ONE OAK STREET PROJECT

CITY AND COUNTY OF SAN FRANCISCO
PLANNING DEPARTMENT: CASE NO. 2009.0159E

DATE: June 1, 2017
TO: Members of the Planning Commission and Interested Parties
FROM: Lisa Gibson, Environmental Review Officer
Re: **Attached Responses to Comments on Draft Environmental
Impact Report Case No. 2009.0159E, 1500 Market St. (One Oak)**

ONE OAK STREET PROJECT

FIGURE RTC-2: REGIONAL FREEWAY FACILITIES

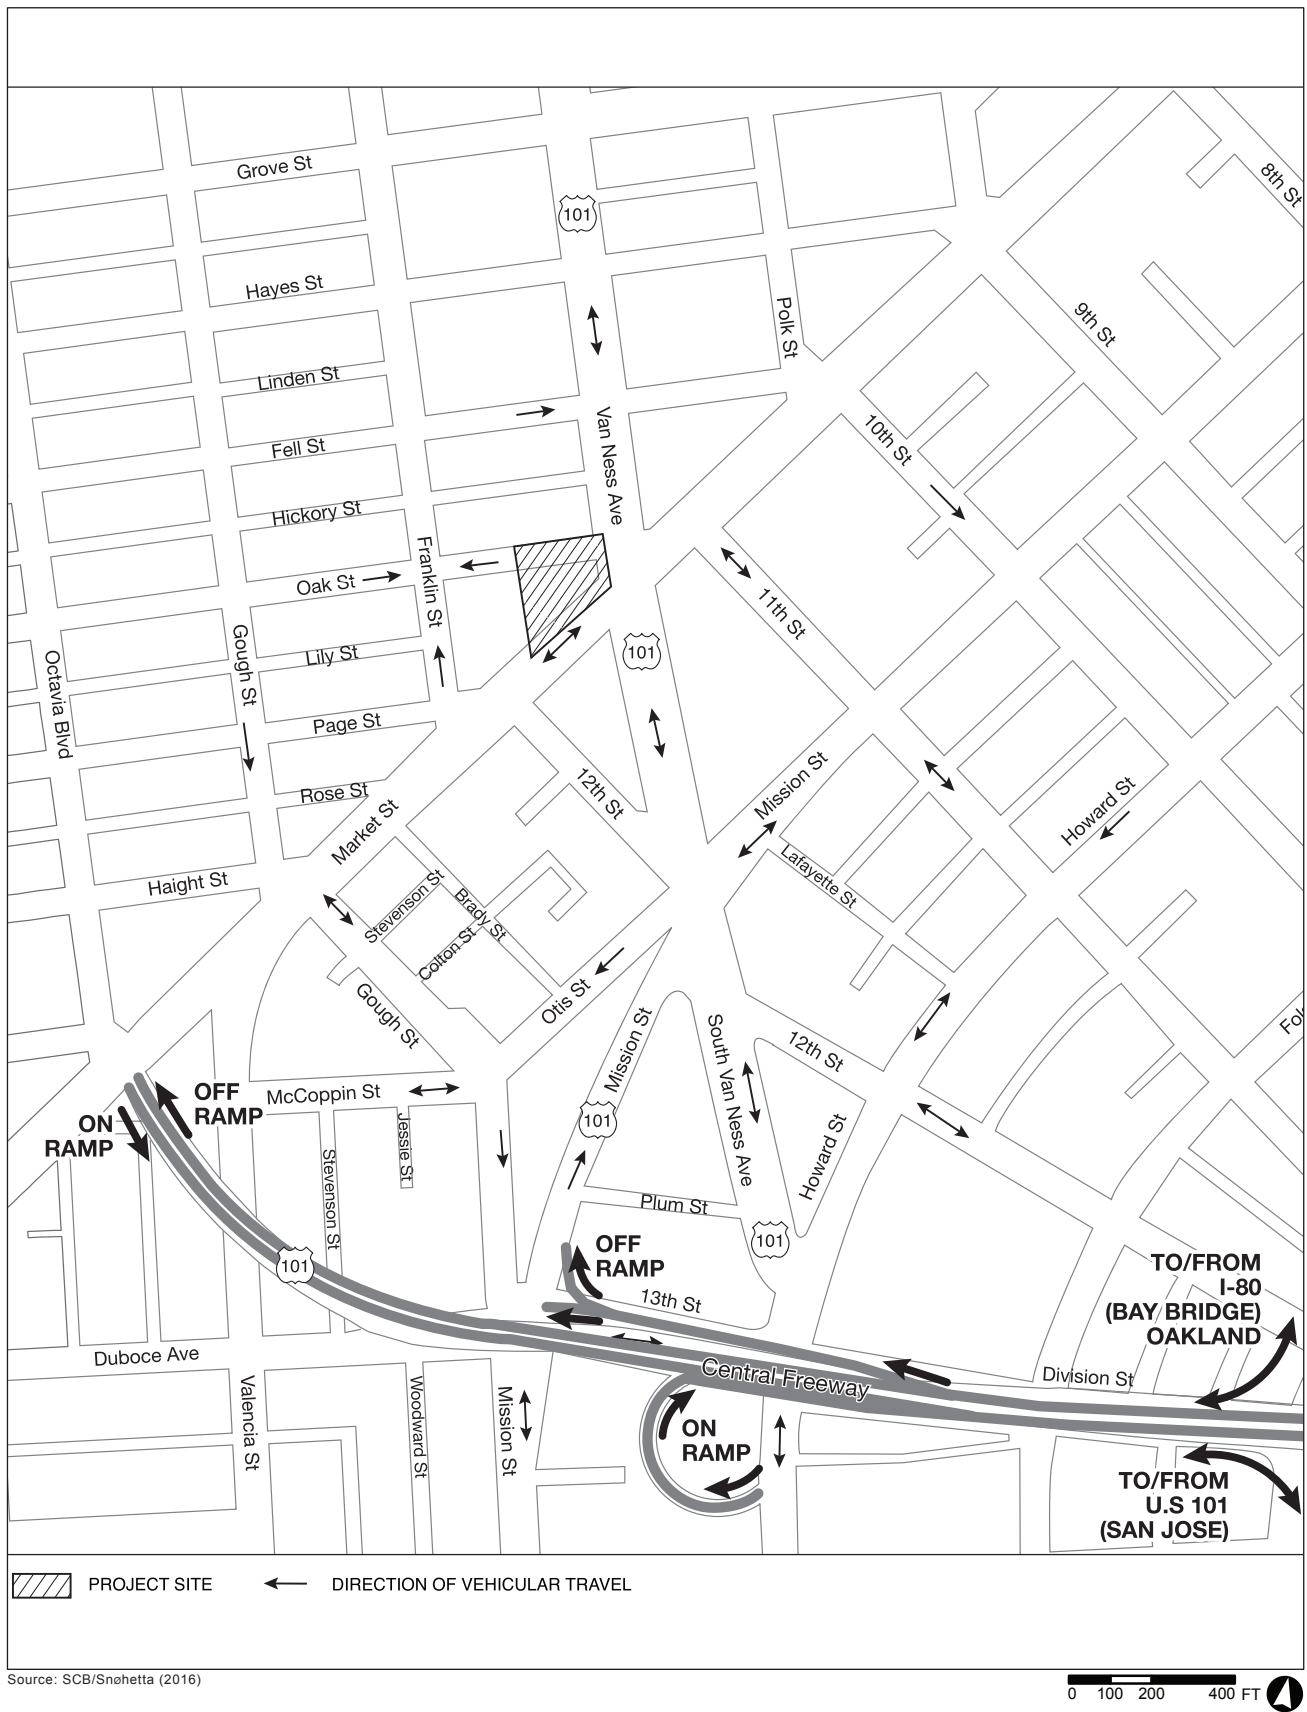
“A MAP of the freeway access and ramps will help understand travel patterns and possible impacts. And direct attention to the excessive parking provided in this "TRANSIT RICH" area. There is a freeway off ramp AT THE CORNER to the right of the Planning Department. There is an on ramp at South Van Ness and 13th. There is a Central Freeway ramp BEHIND the Planning Department. (*Sue C. Hestor, Letter, January 10, 2017 [I-Hestor2-4]*)

The comment requests a map presenting the nearby freeways access ramps. **Figure RTC-2: Regional Freeway Facilities**, presented on the next page, identifies the regional freeway connections in the vicinity of the project site. The project site is about 1,600 feet east of the U.S. 101 ramps at Octavia Boulevard, 1,900 feet north of the U.S. 101 off-ramp at Mission Street, and 2,200 feet north of the U.S. 101 on-ramp at South Van Ness Avenue. Access between the project site and the freeway facilities is described on EIR pp. 4.C.1-4.C.2, and therefore the EIR text does not need to be amended to state that the freeway ramps are used to enter and exit San Francisco.
